In The Drawings

ANNOTATED SHEET SHOWING CHANGES

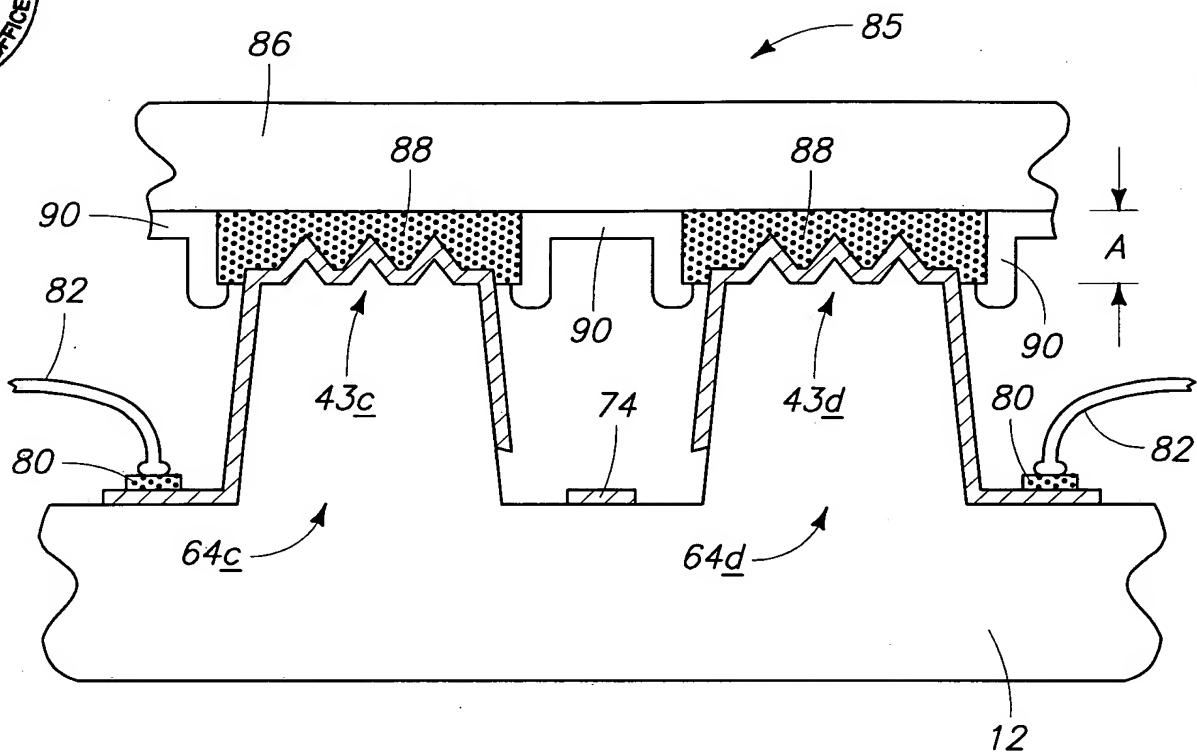
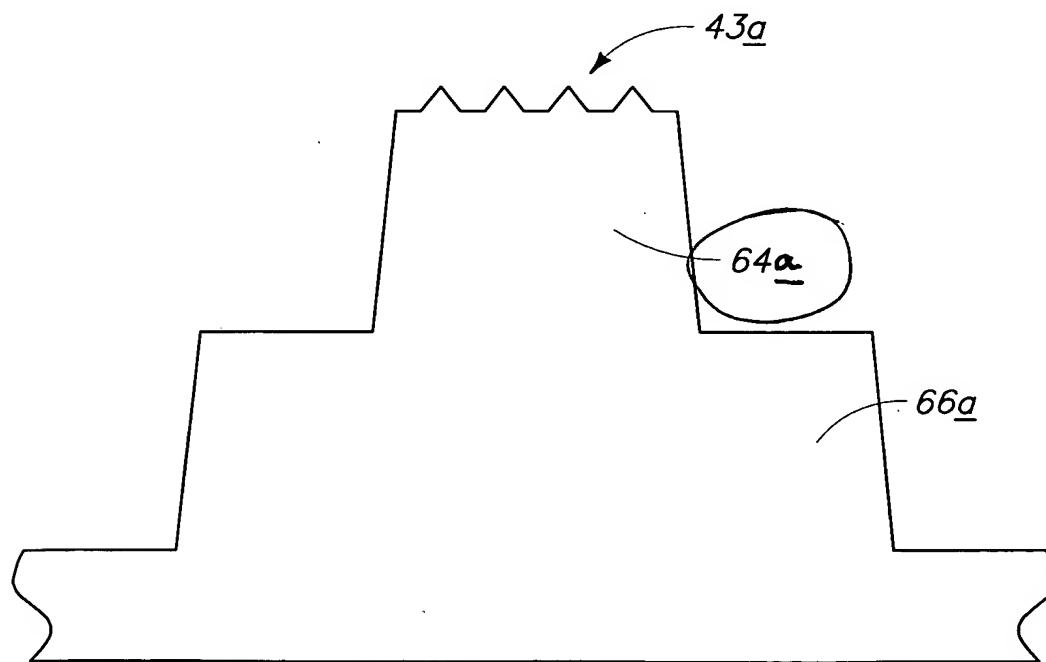
Please amend Fig. 15 of sheet 8 as shown on the enclosed marked-up-in-red copy thereof. A revised formal drawing is enclosed under separate cover addressed to the Chief Draftsman. Acknowledgment of receipt of the formal drawing sheet and its acceptance into the file is requested.

Fig. 15 of the drawings is amended to correct an inadvertent error. Support for the amendment is provided by the originally-filed application at page 14, line 17.
